BA769-A

Re: Catfish Creek - Bank  
Stability, Hwy. #3, Station  
116+00 to 123+00, near New  
Sarum Twp., Yarmouth.

S6913  
REPORT  
TO  
DEPARTMENT OF HIGHWAYS, ONTARIO  
ON  
SOIL CONDITIONS AND STABILITY ANALYSIS  
HIGHWAY 3  
NEW SARUM ONTARIO

SECTION B-B  
SCALE 1" = 20'-0"

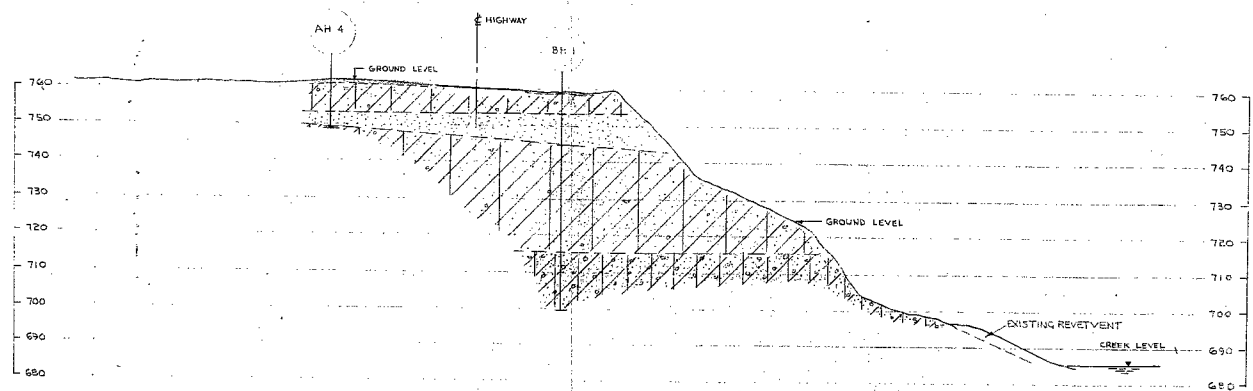
Alternative methods of partial stabilization and re-alignment may prove more economical. One such method entails trimming the banks to the required slopes and then sodding. Wire mesh would be required to hold the sod in place until the grass roots were sufficiently developed. Tile drains should be installed to intercept and drain off water seeping through the sand beam indicated by Geocon's drawing No. S6913-1, Section B-B. A second method consisting of blanketing the area with
